# 1299 Richmond Road, Ottawa

Design Brief

Issued for Site Plan Approval Resubmission  
17 September 2024

## Summary of Urban Design, Parkland and Architectural Related Comments

7.1 City Comments Graphical Representation

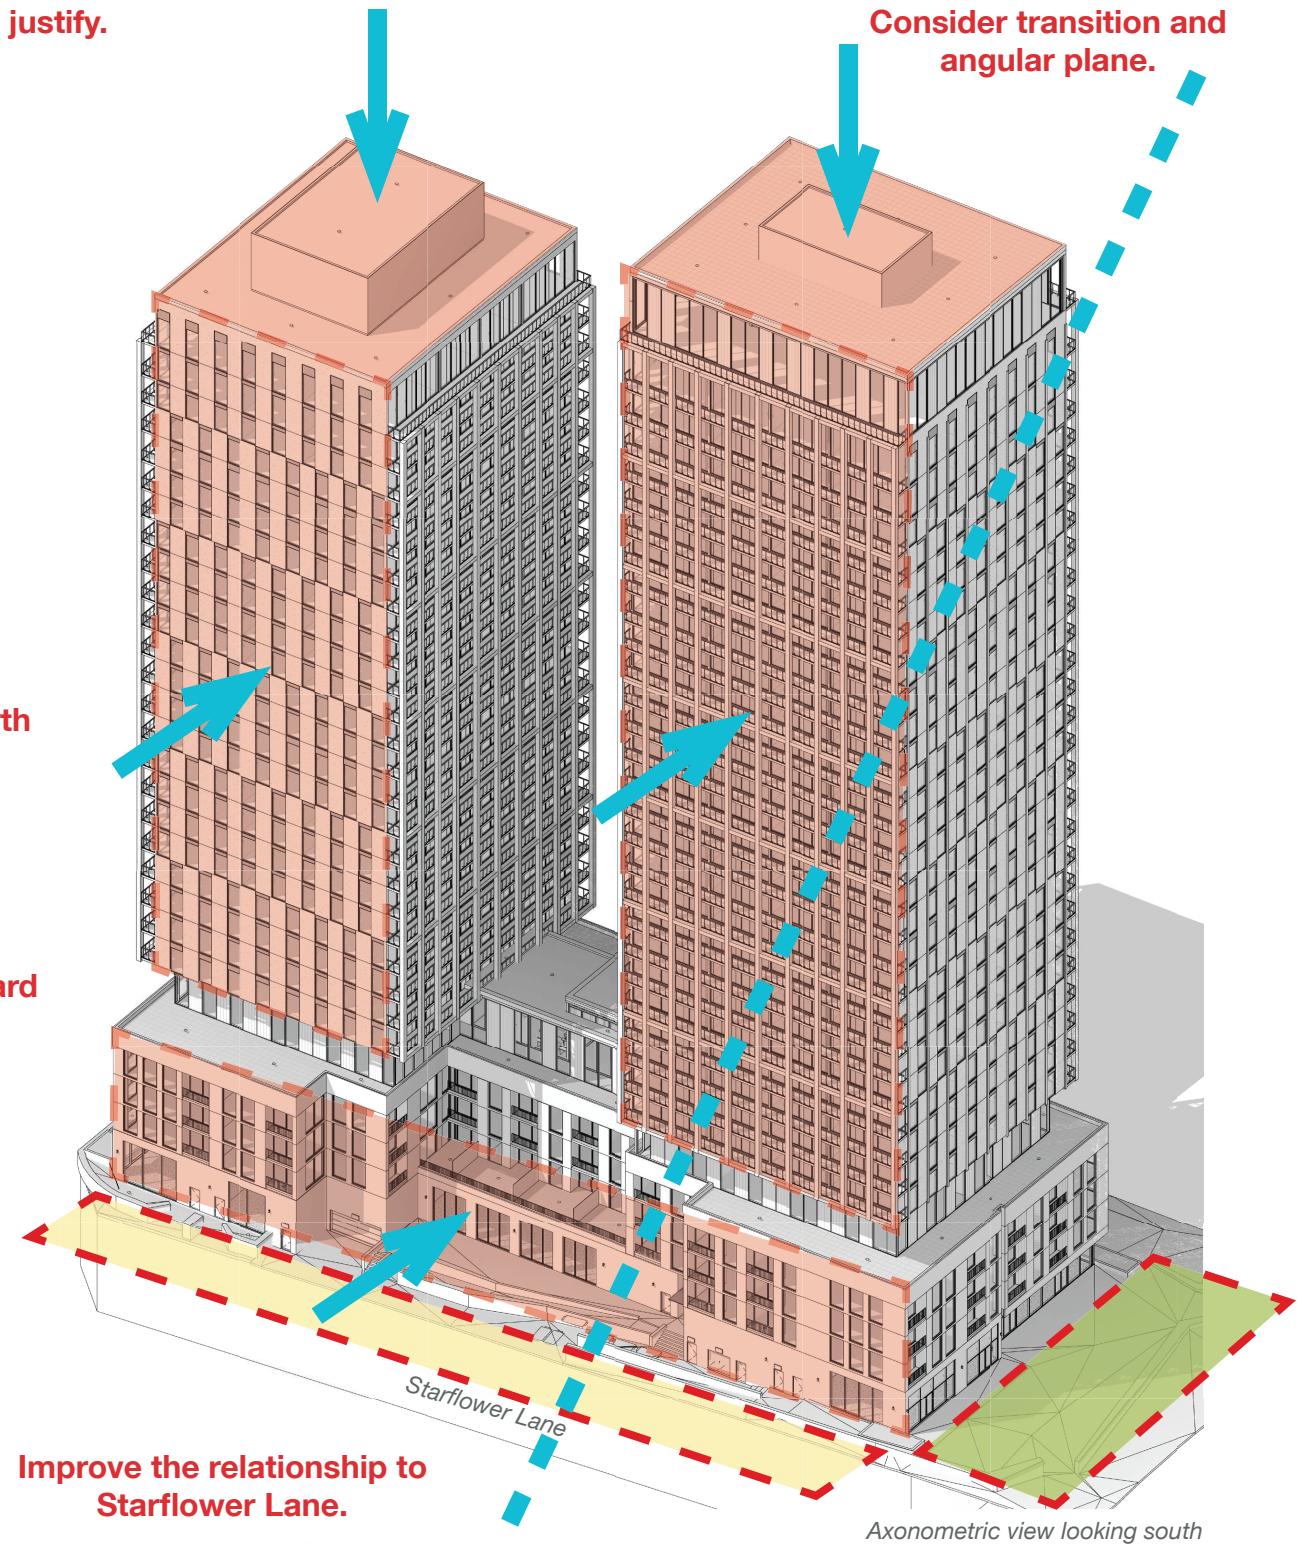
Parkland dedication is too small and difficult to program with public amenities. Cash-in-lieu is acceptable.

Tower heights are difficult to justify.

Towers are too close to the north property line.

Maintain minimum 7.5 m rear yard setback at podium.

Podium is too monolithic.

Consider transition and angular plane.

Improve the relationship to Starflower Lane.

8.3 UDRP Design Comments - Graphical Representation

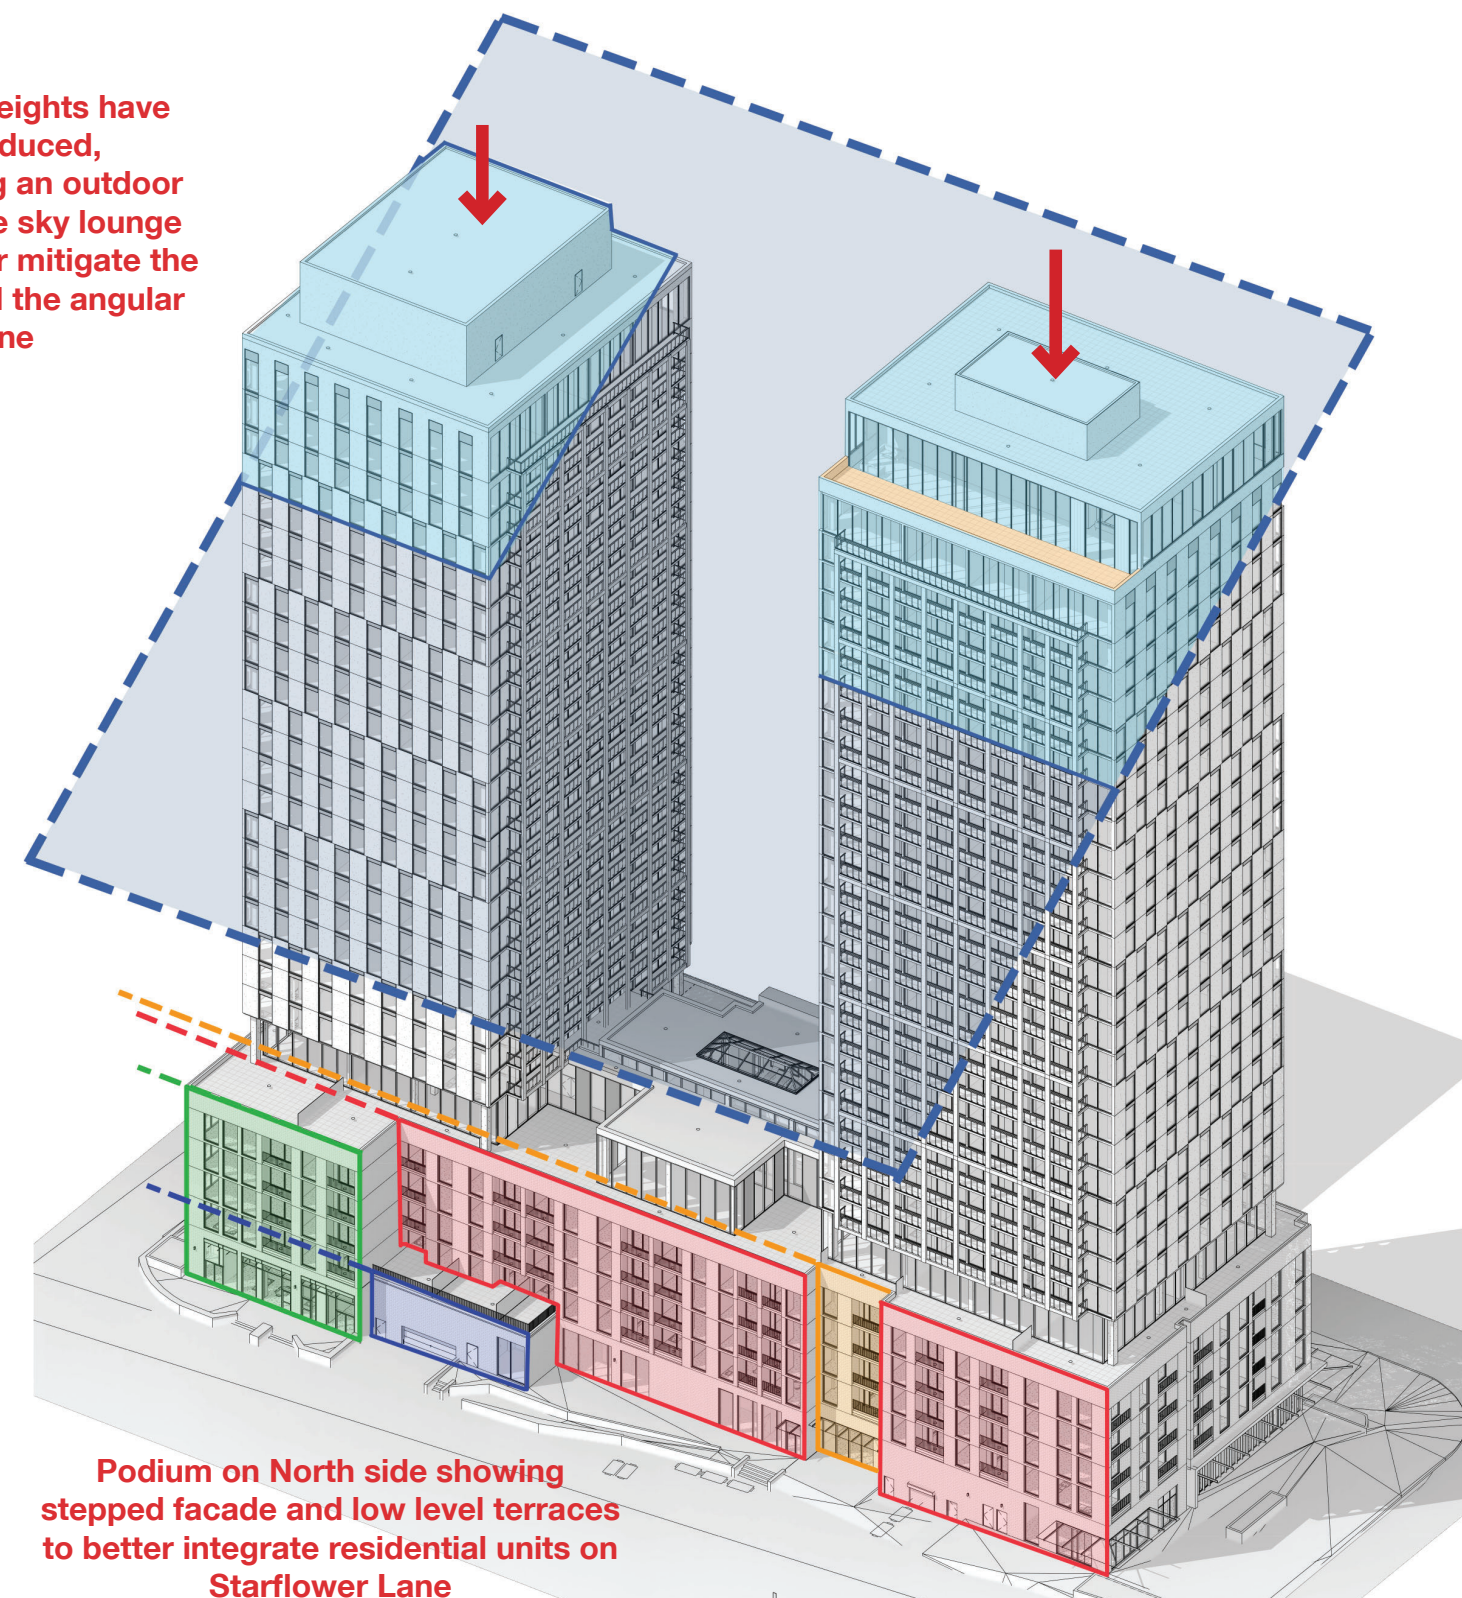
- **Podium Revisions:** Appreciate revisions to the podium along Richmond Road. Explore a high central lobby with a tall atrium connected to the amenity and green spaces.
- **Podium Material:** Address concerns about the flat white podium base by considering neutral masonry materials, preferably beige.
- **Stepped Podium:** Explore a stepped podium on the north side with residential units at grade, creating a residential feel along Starflower Lane.
- **Plaza Access:** Further develop access from the plaza to the podium's central amenity feature.
- **Podium and Public Realm:** Further consider how the podium corners interact with the public realm, especially along Richmond Road

Squeezing balcony lengths at the edges to give a more slender look for towers and also integrate the corners in a better way.

Podium main entrances are inset accentuated with green material within an overall beige brick podium.

The podium's central plaza features a prominent vertical element that connects all floors to the amenities, adding distinct character to Piazzetta's public realm

The tower heights have been reduced, incorporating an outdoor terrace at the sky lounge level to further mitigate the mass beyond the angular plane

Podium on North side showing stepped facade and low level terraces to better integrate residential units on Starflower Lane
